RE: Riverview  
Response to PLUS Review #2008-01-10 Comments

Thank you for your letter of February 25, 2008, containing the comments from State Agencies regarding the Riverview Conceptual Development Plan. Our responses to State Agency comments are as follows:

SITE PLAN  
1" = 400'

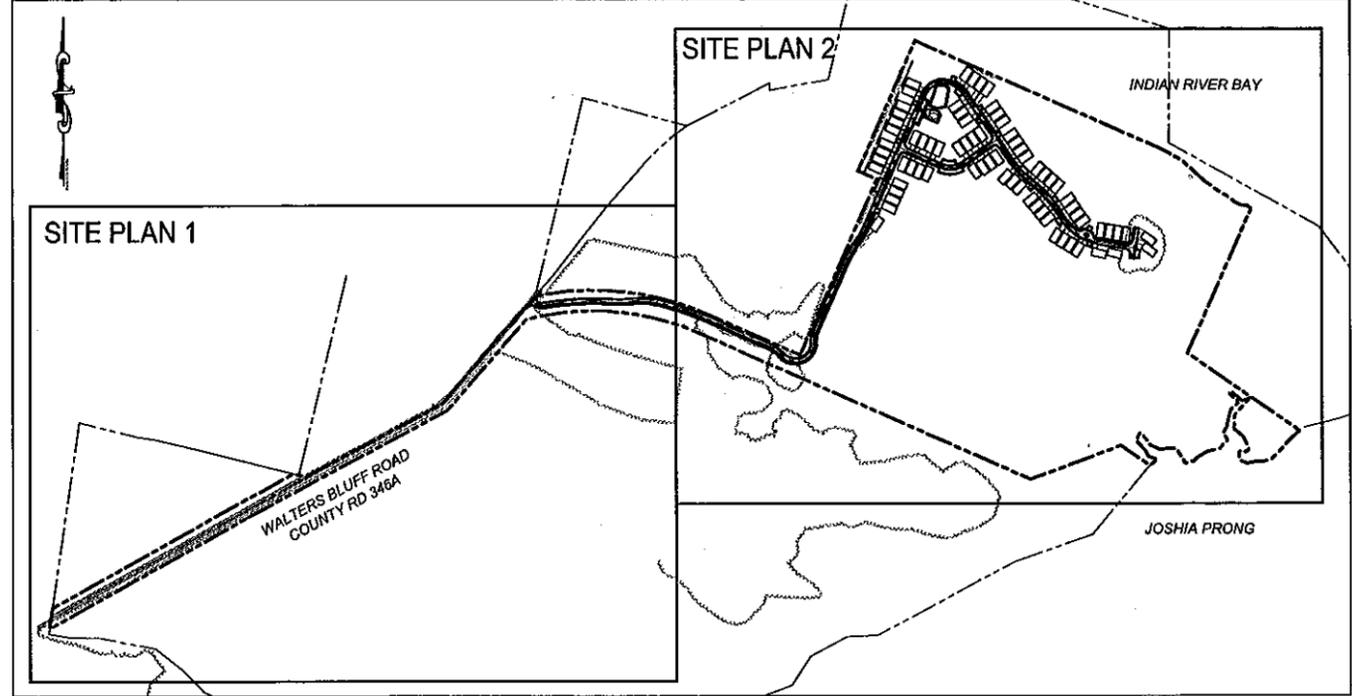
***The new site plan proposes two wetland walkways, each crossing several hundred linear feet of tidal wetlands. These structures far exceed the recommendations for wetland walkways in the WSLS Guidance Document and also exceed the lengths of walkways authorized by the Department for at least the past 5 years. Because the peninsula is surrounded by large expanses of tidal wetlands and construction of walkways would create significant impacts to wetlands, authorization for a wetland walkway would be difficult to obtain.***

***Long-term degradation of the marsh habitat could occur from the fragmentation and disturbance caused by this development. This project has the potential to impact a large expanse of wetlands because inadequate upland buffers are being proposed, wetlands will have to be filled for the access road and wetlands will be disturbed and fragmented by two long docks.***

***The two docks being proposed will bisect and fragment the wetlands. Species utilizing the wetlands could be disturbed, not only during construction of the docks, but also when residents use the docks. This could especially impact birds that are attempting to nest, are incubating eggs or tending to young. In addition, the shoreline where the docks terminate could potentially be diamondback terrapin nesting habitat. The diamondback terrapin is a brackish water turtle found in the state's coastal inland bays, Delaware Bay and its tidal brackish tributaries. This species is considered to be a species of conservation concern, but there is inadequate data to determine degree of rarity. The Northeast Wildlife Diversity and Endangered Species Technical Committee consider the Diamondback terrapin a species of regional concern, and one that may warrant federal protection in the future. This species spends most of its life in the water, until spring when (primarily) females seek open upland sandy areas to lay eggs. Hatchlings utilize adjacent marsh areas as a nursery area.***

All non-tidal wetlands are delineated on the plans in accordance with the Jurisdictional Determination as approved by the US Dept. of the Army. The tidal wetlands delineated on the conceptual plan submitted for PLUS review were delineated in accordance with the SWMP maps. However, as a result of field review by representatives of the DNREC Wetland and Subaqueous Lands Section and our wetland consultant, Environmental Resources, Inc., following the PLUS submittal, modifications in the tidal wetland boundary were required. As a result of these tidal wetland boundary adjustments, minor modifications to the proposed home configuration were required. The new plan continues to have no homes located within wetland areas and all wetland impacts, other than the entry roadway, have been avoided. A copy of the letter received from the WSLs is attached as Attachment A, and the modified plan is attached to this letter as Attachment B.

The two boardwalks which were shown on the plan were intended to provide a means of providing pedestrian access to the sections of sandy beach which are located on the property. As they were only intended to enhance the development, and are not necessary to otherwise develop the site, we have removed them from the modified plan. Please refer to Attachment B.

As previously mentioned, there is no law requiring a 100 foot buffer, and the required 50 foot buffer has been provided in all locations. In addition, the two docks shown on the plan will be removed from the plan.

BULKHEAD ACCESS ROAD THROUGH WETLANDS  
TYPICAL SECTION C-C  
N.T.S.

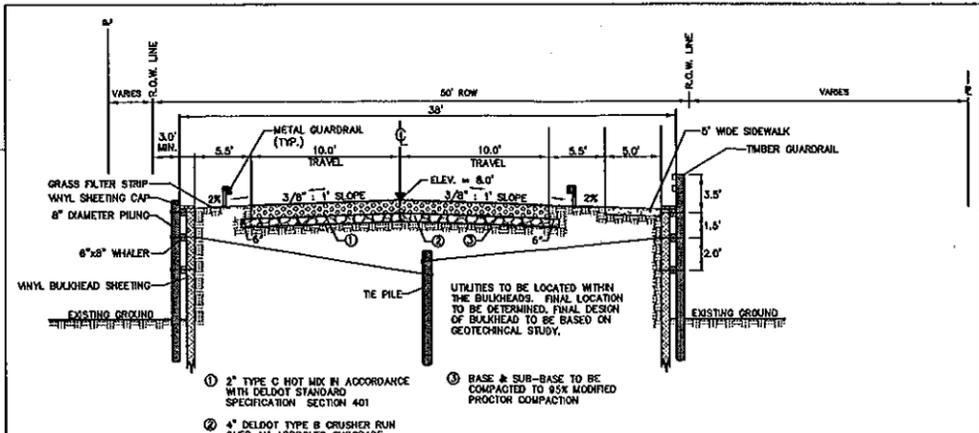
***The Wetland and Subaqueous Lands Section (WSLS) has serious concerns about the placement of fill materials in State-regulated tidal wetlands for an access roadway. It is strongly recommended that a bridge be constructed to avoid impacts to tidal wetlands.***

***In the "Project Summary" that accompanied the PLUS application form, the applicant states that the Riverview neighborhood has been designed with the "health, safety, and welfare of the citizen's of Sussex County" [in mind]. The existing topography of the parcel goes from less than 2 feet to a small peak of 8 feet NAVD 88. The Base Flood Elevation on the portion of the property where the road will be located is 6.7 NAVD 88. This portion of the parcel is located in Flood zone AE 7 for Indian River Bay. A small portion of the property is in flood zone AE 8 and the Northeast corner is in zone VE 9. Essentially the road would be constructed almost 5 feet below the 100-year base flood elevation if it was constructed on existing grade. It is our understanding that fill will be used to construct the road. Given that the road crosses a wetland and is located in a State Resource Area (SRA), what is the likelihood that more than five feet of fill would be used to elevate the road? From a public safety standpoint, the lives of the 72 property owners and their families could be at risk, as well as the lives of any emergency personnel that would be required to access this subdivision in the event of a storm.***

We understand, and appreciate, the WSLS's desire to span the onsite tidal wetlands with a bridge. However, as previously stated, the Sussex County Council conditioned their previous approval of this property such that a bridge was prohibited. Based on conversations with the WSLS, we have agreed to revisit this issue during our upcoming public hearings before the Sussex County Planning & Zoning Commission and Sussex County Council, and have even requested the WSLS to prepare a letter specifically outlining their request, and forward it to the Sussex County Office of Planning & Zoning.

The access road is proposed to be constructed above the Base Flood Elevation through the placement of fill within vinyl sheetpiling to limit the required access roads footprint. This roadway will be designed to be safe under all weather conditions that a non-fill road section would be considered safe. Furthermore, the construction of the remainder of the onsite roadways below the Base Flood Elevation is in keeping with the development practices of practically every other coastal development in the Sussex County area. In fact, a quick review of the surrounding area indicates that the majority of the coastal towns, as well as most other major and minor coastal developments have been developed in a similar manner.
